UNIVERSITY OF LOUISVILLE
LOUISVILLE, KENTUCKY 40208

March 4, 1981

The objective of Prof. Alexander's analysis was to investigate the actual confidence of the S&L/PSI evaluation study of in-place concrete at Marble Hill performed by Construction Technology Laboratories. His analysis establishes a specification which considers the risk associated with the sampling plan used at Marble Hill involving 60 test sites. Inherent in the S&L plan, which is intended to assure with a confidence level of 95% that no more than 5% of the concrete volume is defective, is the assumption that no test error exists. The analysis is intended to determine the risk associated with this assumption. Thus, the probability that defective concrete will be erroneously accepted is not conjoined with the probability of finding defective concrete in the S&L plan. This omission results in a plan that inevitably provides less than the required 95% confidence.

This is a critique of the section "Statistical Basis for Testing Program" (Section III - Pgs. 4-8) included in the report SL-3753 - Revision 1. This critique was prepared by Suraj M. Alexander, Ph.D., P.E., Asst. Professor, Engineering Management/Industrial

Figure 1

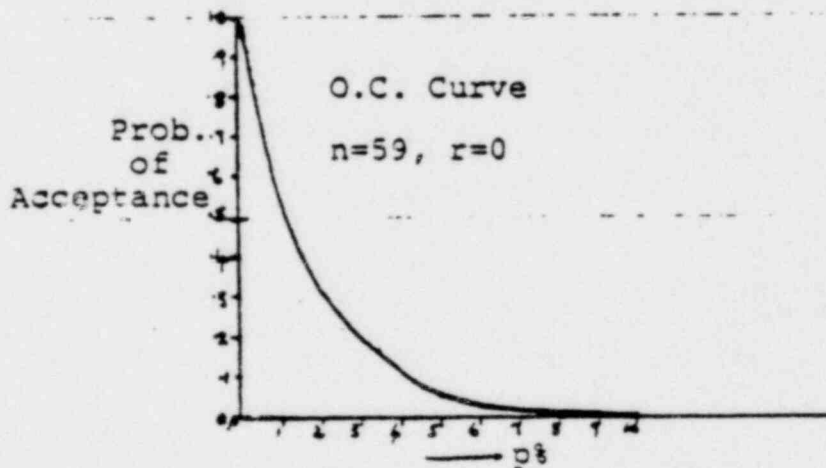
samples should fail the test". If the sampling plan selected was used as a single sampling plan, (i.e. Sample size $n = 59$, Acceptance number $r = 0$); it would reject a population with 5% defective 95% of the time. In order to understand what happens to populations with larger and fewer defective percentages an Operations Characteristic (O.C.) curve must be constructed for the sampling plan. As an example the O.C. Curve shown in Figure (1), which was plotted after some rough calculations were made by me, detail the probabilities of acceptance of different quality populations using a single sampling plan with $n = 59$ and $r = 0$.

Thus if the sampling plan was a single sampling plan (the equations used to derive n are only valid for a single sampling plan) the risks associated with using the plan is best illustrated by the O.C. Curve Figure (1). These risks have not been specified by S & L in their statistical program.
